Plan Change Request

Project Information	
Site Address/ Parcel #: 707 39th Ave SE	Permit #: PRCCP20231028 PCR 002
Owner: Wesley Homes -Kevin Anderson	Email: kanderson@wesleyhomes.com
Design Engineer: Dan Balmelli	Email: dbalmelli@barghausen.com
Contractor: Walsh Construction Company - Anthony Mizi	n Email: amizin@walshconstruction.com
Originator of the Request: ■ Owner □ Design	n Engineer □ Contractor □ City of Puyallup
Does this request require a <u>deviation</u> from city so	andards? ☐ Yes
If yes, submit an <u>Alternative Method's Request</u> vis	the <u>CityView Portal</u> instead of this form
Indicate the development infrastructure being affected	d
☐ Road ☐ Storm ☐ Water	■ Sanitary □ Grading □ Erosion Control
Specify the approved civil plans affected: C2, C5-C1	3
Describe the change(s) being requested: Building footprint revision to the New Care Center and revisions to associated grade	
In addition, some minor adjustments to water and sewer utilities for the Brownst

PHASE 2 - WESLEY BRADLEY PARK

LANDSCAPE PLAN NORTH

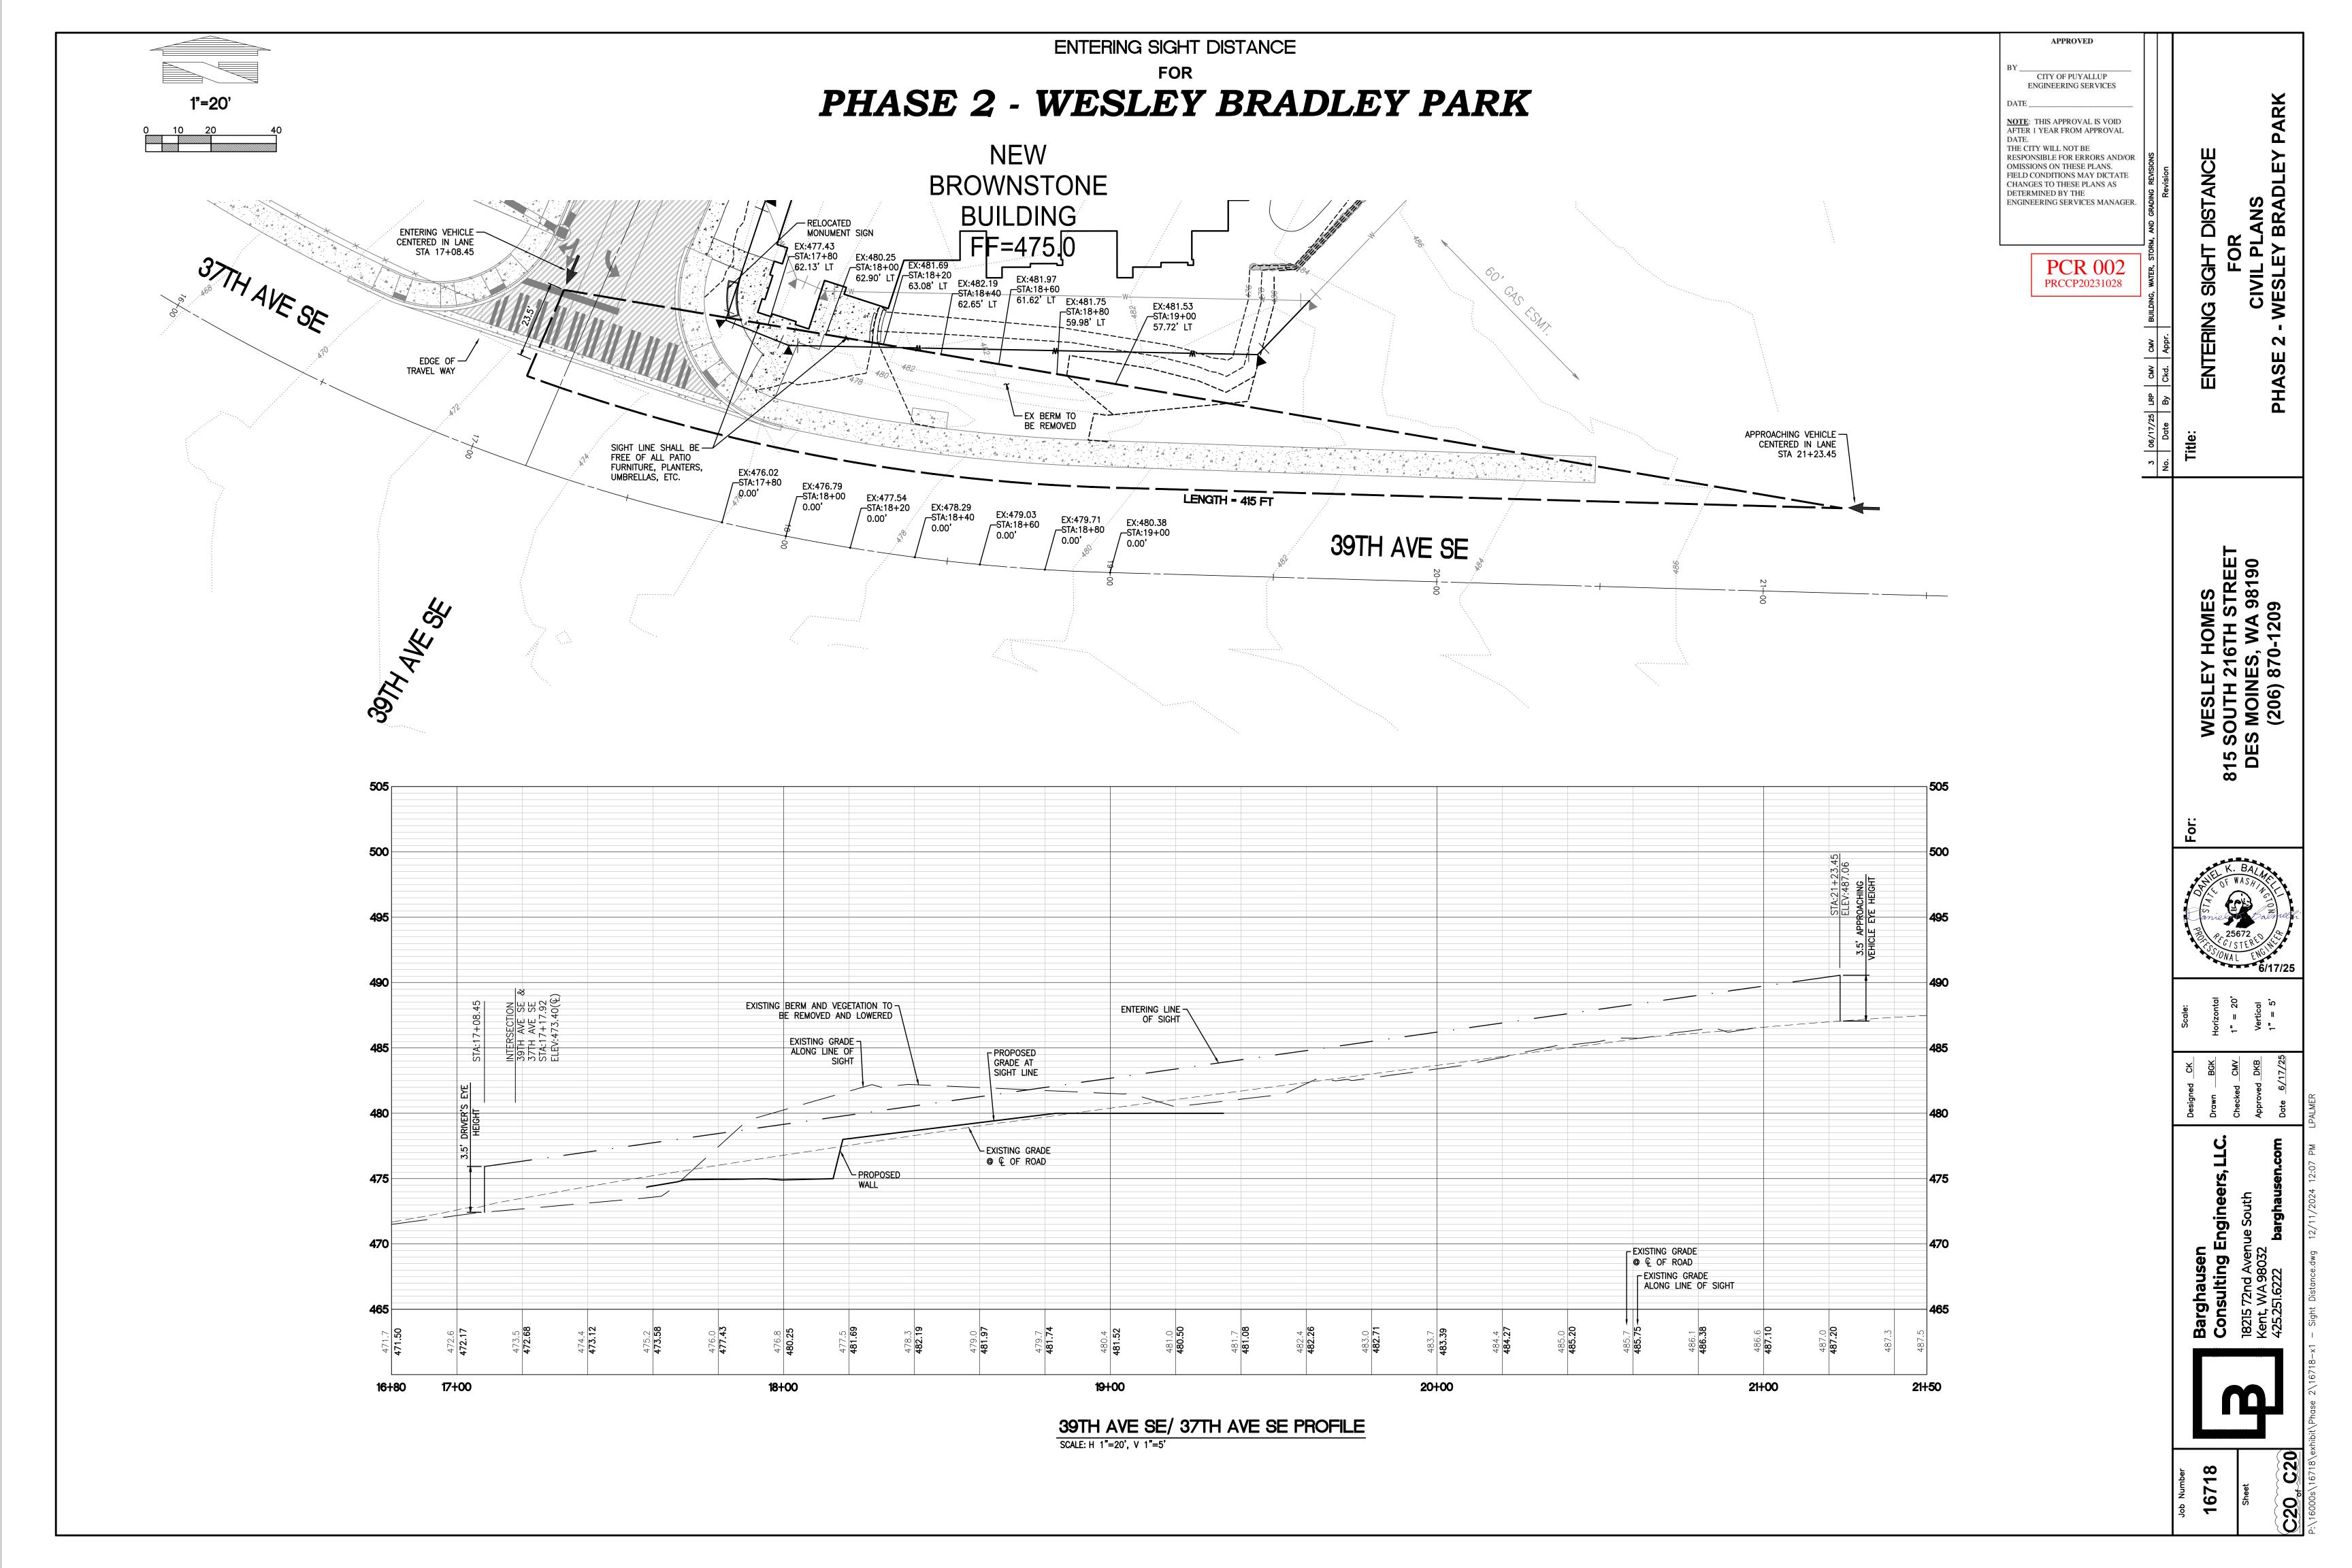
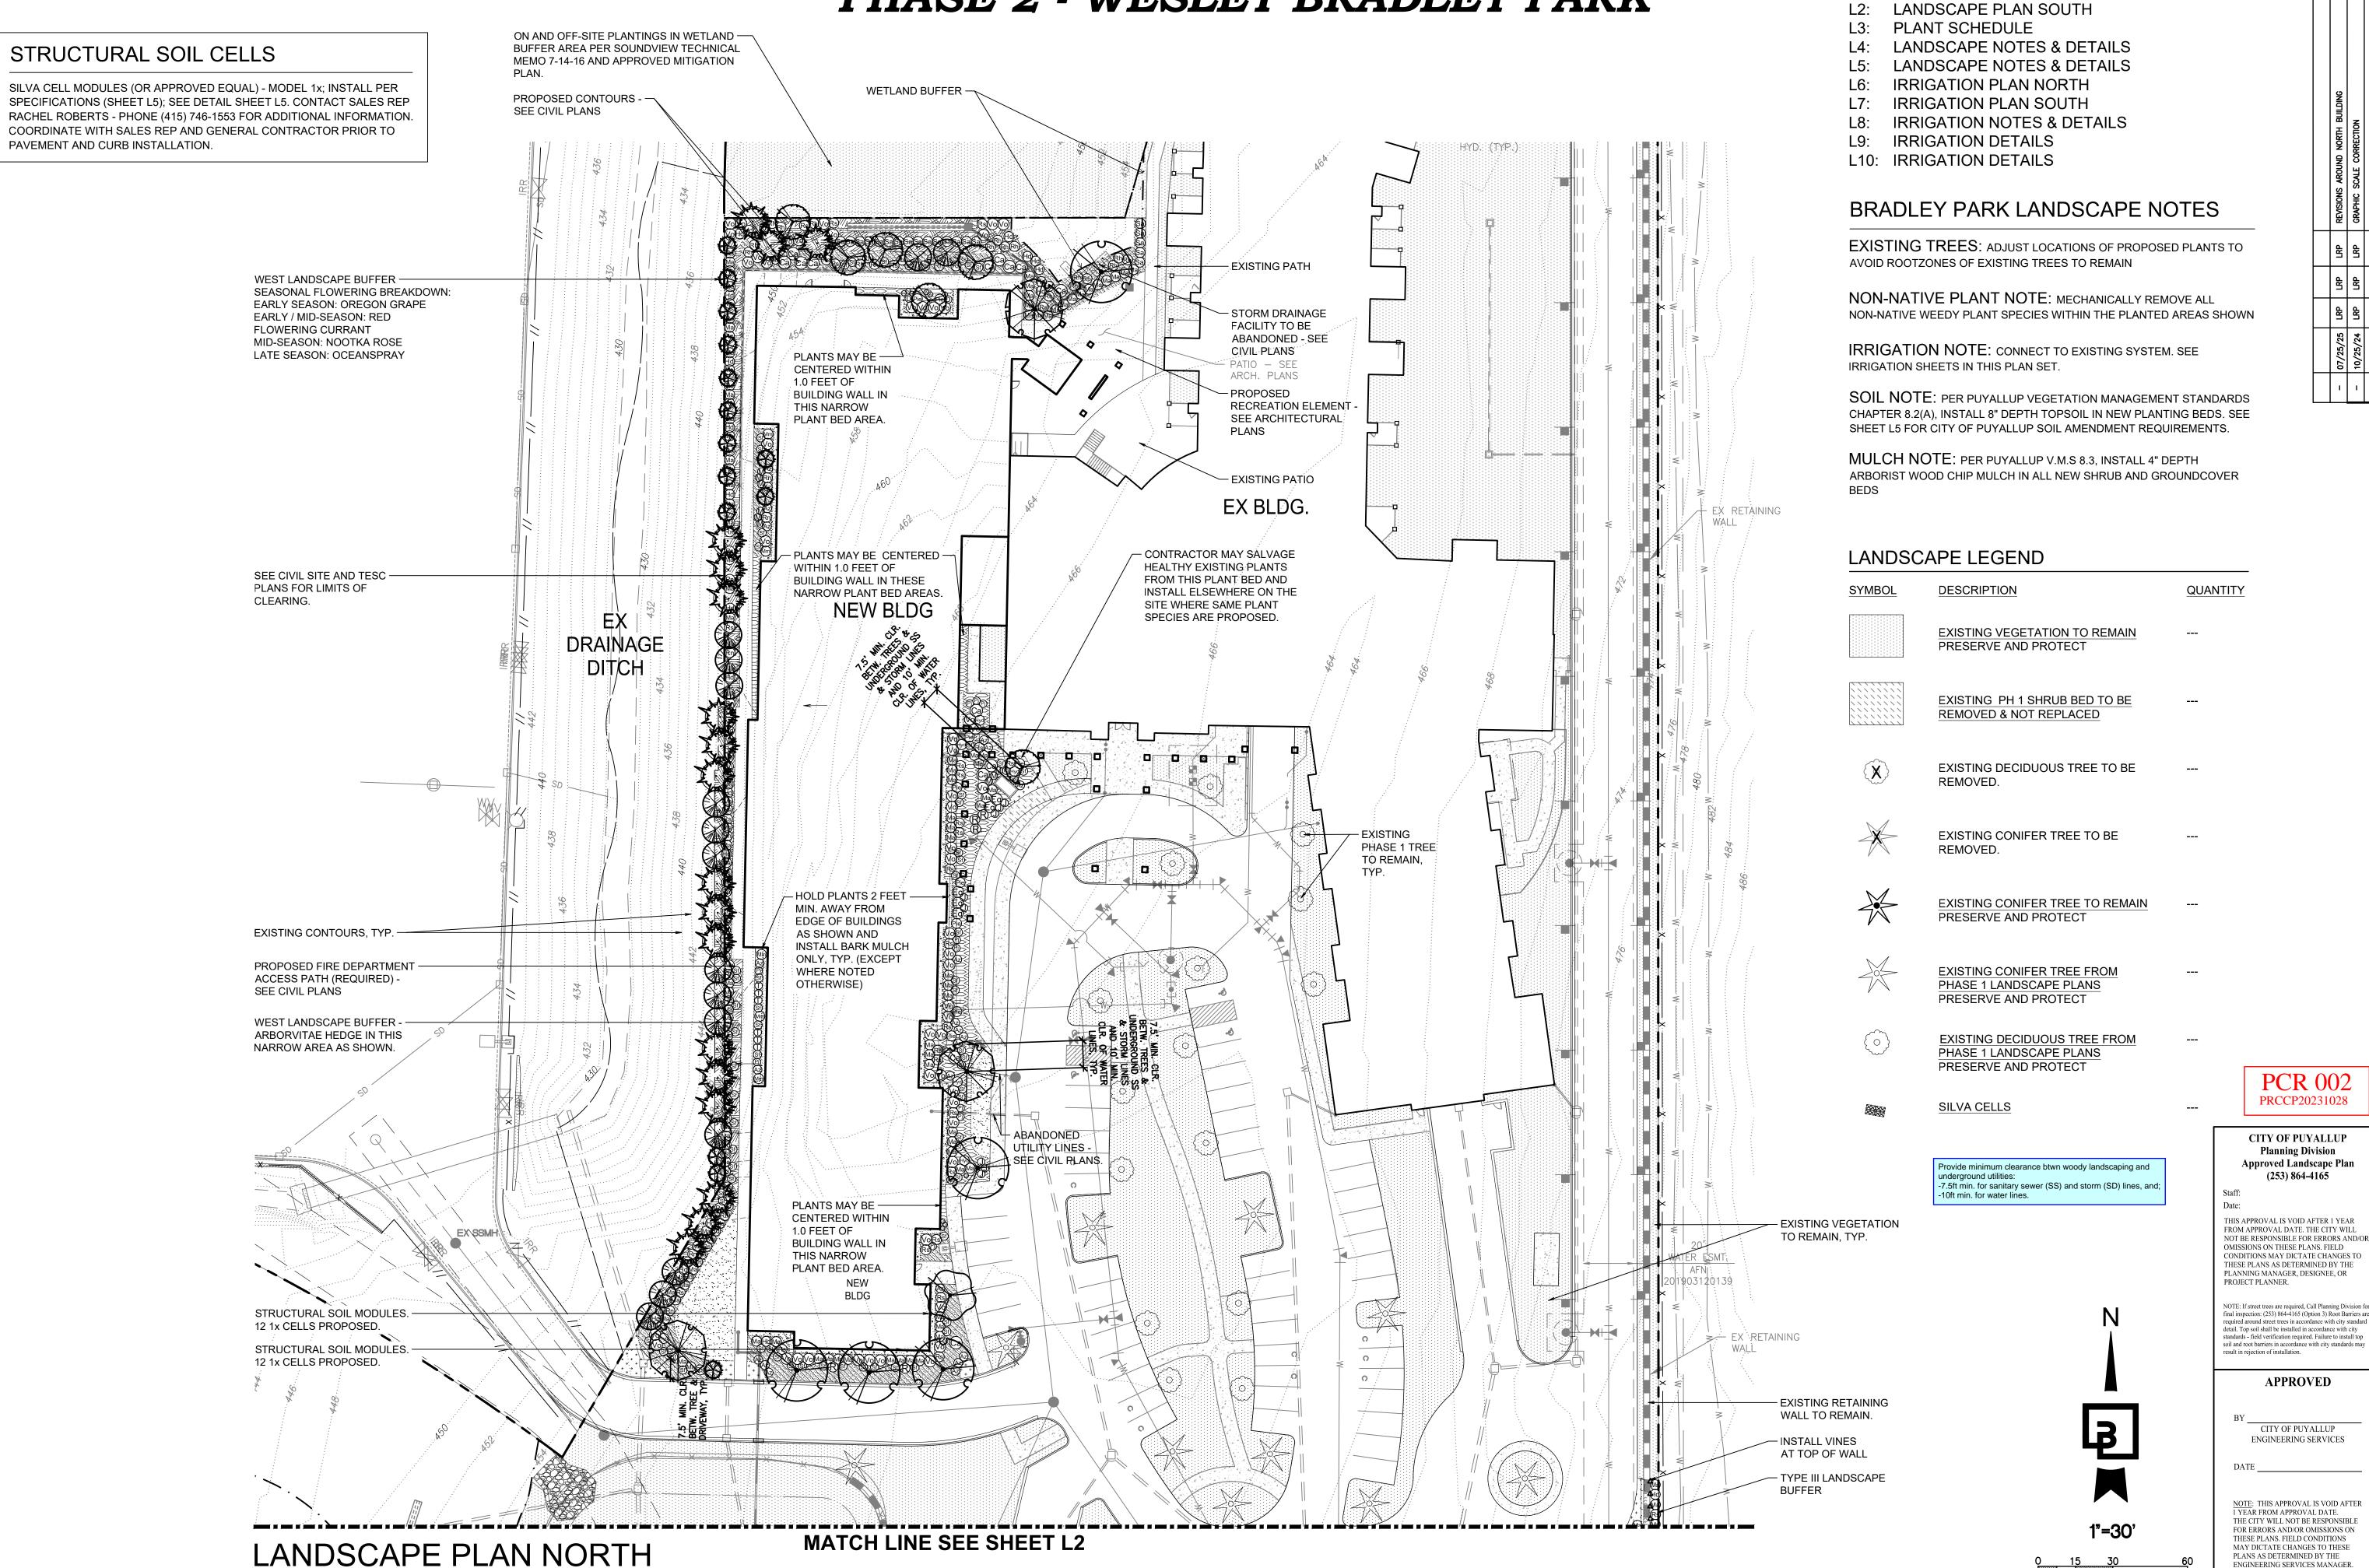
Provide minimum clearance btwn woody landscaping and -7.5ft min. for sanitary sewer (SS) and storm (SD) lines, and; -10ft min. for water lines.
